iv) Drainage Plan

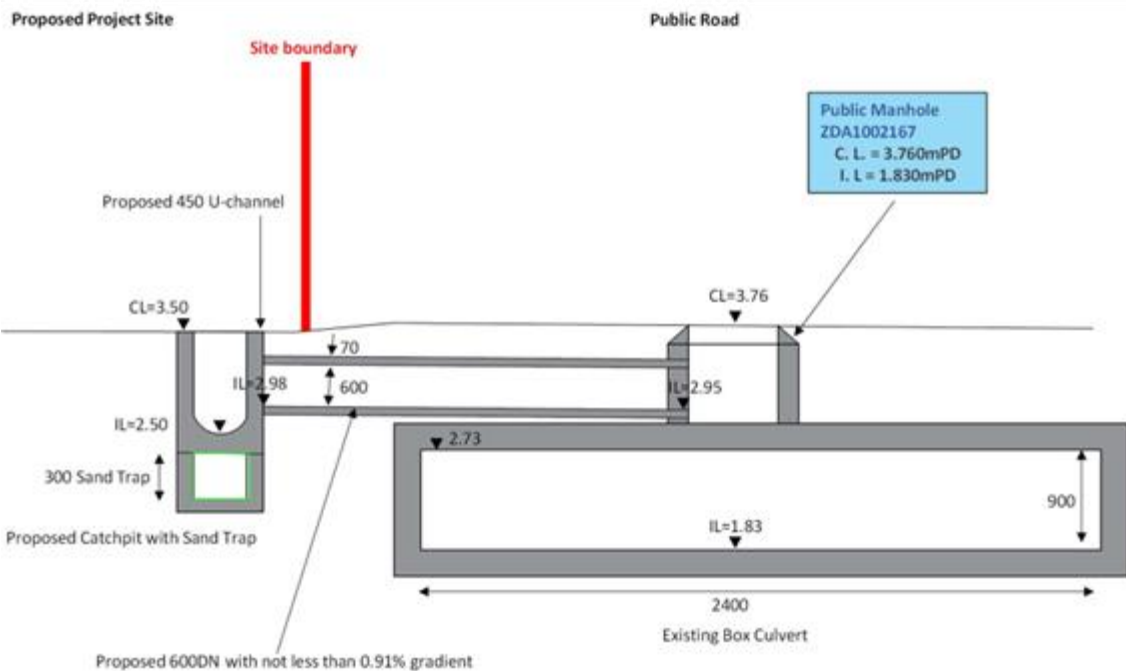
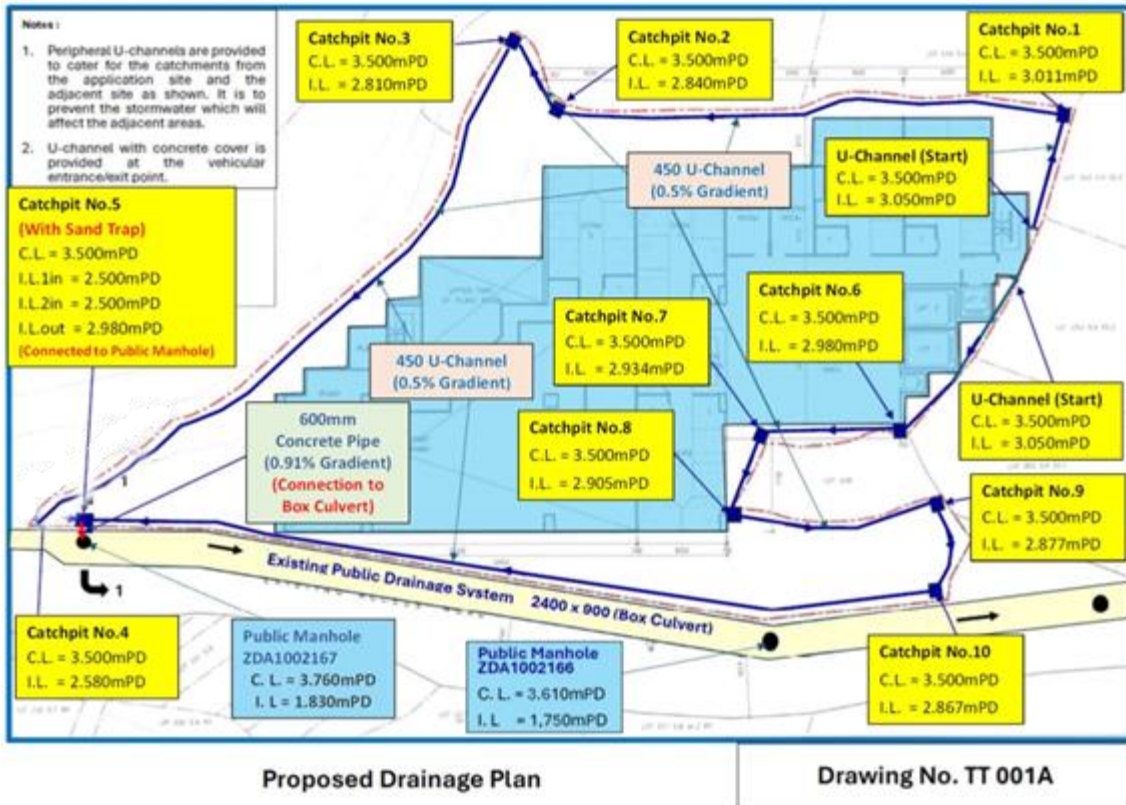
Details and method statement for connection of proposed DN600 pipe to the existing box culvert should be submitted for DSD's approval before the connection works. CCTV inspection should be conducted before and after the connection works. DSD should be
